# UNITED STATES PATENT AND TRADEMARK OFFICE

Leonhard Fuchs

<b>Office Action Summary</b>	<b>Application No.</b> 10/586,222	<b>Applicant(s)</b> FUCHS ET AL.	
	<b>Examiner</b> CHESTER T. BARRY	<b>Art Unit</b> 1797

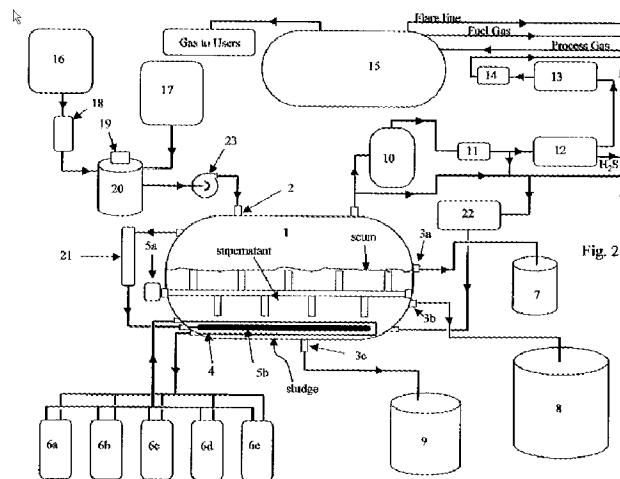
Claims 12, 15 are rejected under 35 U.S.C. 102(b) as being anticipated by USP 20020079266 to Ainsworth. USP 20020079266 to Ainsworth describes a tank 20 fluidly

connected via pump 23 to tank 1. Applicants' claim-recited "raw sludge tank" reads on Ainsworth's tank 20 because 1) tank 20 appears capable of containing raw sludge, and 2) applicants' device claims do not require that the "raw sludge tank" contain raw sludge. Applicants' "disinfection tank" reads on Ainsworth's tank 1 because 1) tank 1 appears capable of disinfecting partially stabilized sewage sludge, e.g., by heat, addition of a disinfectant, such as chlorine, or by at least one other known manner of disinfection, and 2) applicants' device claims do not require that the "disinfection tank" contain partially stabilized sewage sludge. Applicants' conveying means reads on Ainsworth's pump 23. Per claim 15, the tank 1 has a gas exhaust device and a heater.

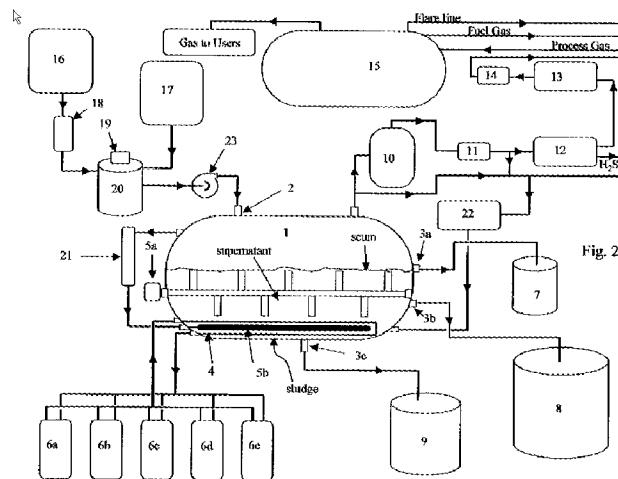
Claims 12, 13, 15 are rejected under 35 U.S.C. 102(b) as being anticipated by USP 20020079266 to Ainsworth. USP 20020079266 to Ainsworth describes a tank 20 fluidly

connected via pump 23 to tank 1. Tank 1 is also fluidly connected to downstream tank 9. Applicants' claim-recited "raw sludge tank" reads on Ainsworth's tank 20 because 1) tank 20 appears capable of containing raw sludge, and 2) applicants' device claims do not require that the "raw sludge tank" contain raw sludge. Applicants' "disinfection tank" reads on Ainsworth's tank 9 because 1) tank 9 appears capable of disinfecting partially stabilized sewage sludge, e.g., by heat, addition of a disinfectant, such as chlorine, or by at least one other known manner of disinfection, and 2) applicants' device claims do not require that the "disinfection tank" contain partially stabilized sewage sludge, although if claim 13 so required, Ainsworth's disclosure of sludge tank 9 would meet that limitation. Applicants' "intermediate tank" reads on Ainsworth's tank 1 because 1) tank 1 is fluidly between tank 20 and tank 9. Applicants' first conveying means reads on Ainsworth's pump 23 insofar as it is located between tank 20 and tank 1 and it appears capable of continuous operation. Ainsworth does not expressly describe a valve in the pipeline between tank 1 and tank 9, but the skilled artisan would have understood that a valve is necessarily present at that location to prevent flow of tank 1

contents into tank 9 before the reactor contents had separated into a settled sludge, scum, or intermediate layer, or until such time as the reaction in tank 1 was complete.

See Ainsworth [0079]. Per claim 15, tank 20 has an agitation device. Per claim 15, the tank 1 has a gas exhaust device and a heater.

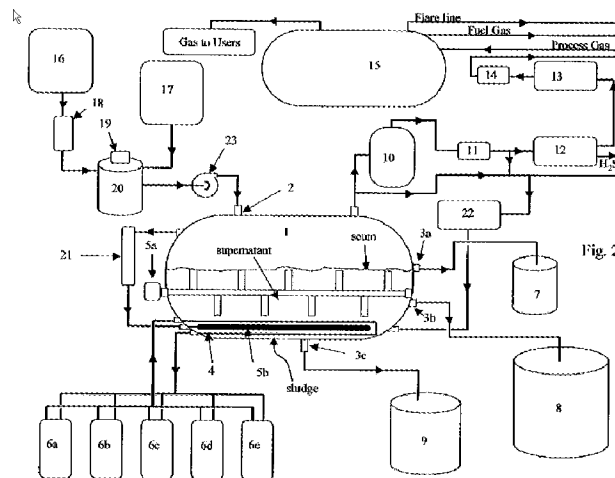
Claims 12, 14 are rejected under 35 U.S.C. 102(b) as being anticipated by USP 20020079266 to Ainsworth. USP 20020079266 to Ainsworth describes a tank 20 fluidly

connected via pump 23 to tank 1. Tank 1 is also fluidly connected to downstream tank 8 and tank 9. Applicants' claim-recited "raw sludge tank" reads on Ainsworth's tank 20 because 1) tank 20 appears capable of containing raw sludge, and 2) applicants' device claims do not require that the "raw sludge tank" contain raw sludge. Applicants' first "disinfection tank" reads on Ainsworth's tank 8 because 1) tank 8 appears capable of disinfecting partially stabilized sewage sludge, e.g., by heat, addition of a disinfectant, such as chlorine, or by at least one other known manner of disinfection, and 2) applicants' device claims do not require that the "disinfection tank" contain partially stabilized sewage sludge. Applicants' second "disinfection tank" reads on Ainsworth's

tank 9 because 1) tank 9 appears capable of disinfecting partially stabilized sewage sludge, e.g., by heat, addition of a disinfectant, such as chlorine, or by at least one other known manner of disinfection, and 2) applicants' device claims do not require that the "disinfection tank" contain partially stabilized sewage sludge, although if claim 14 so required, Ainsworth's disclosure of sludge tank 9 would meet that limitation. Applicants' first conveying means reads on Ainsworth's pump 23 insofar as it is located between tank 20 and tank 1 and it appears capable of continuous operation. Ainsworth does not expressly describe a valve in either the pipeline between tank 1 and tank 8, or between tank 1 and tank 9, but the skilled artisan would have understood that a valve is necessarily present at each of these locations to prevent flow of the tank 1 contents to flow into either downstream tank before the tank 1 contents had separated into a settled sludge and intermediate layer, or until such time as the reaction in tank 1 was complete. See Ainsworth [0079].
